Addendum 2

Supply Ontario

Request for Tender
tender_ 19481

Construction of an Aquaculture Rearing Building

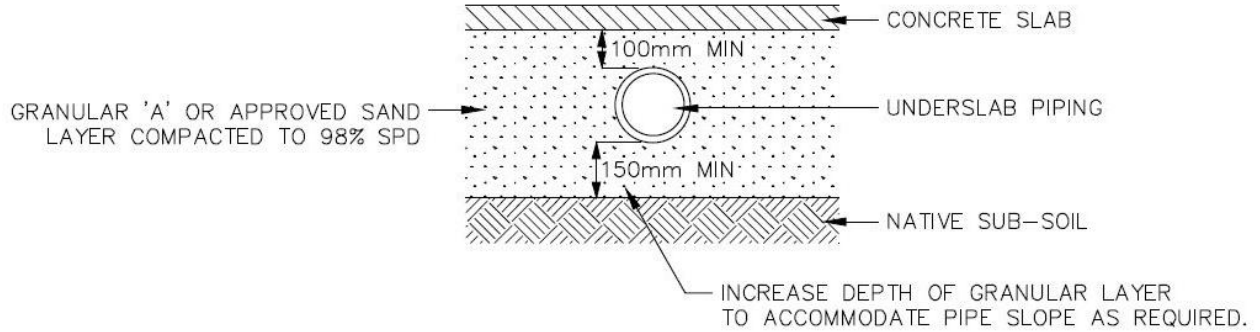
24. Extension of completion date

Dates have continually shifted for posting this procurement along with the deadline for bid submissions. Please see revised dates.

Previous substantial completion date: October 25, 2024

New substantial completion date: January 24, 2025

Previous completion date: November 1, 2024

New completion date: January 31, 2025
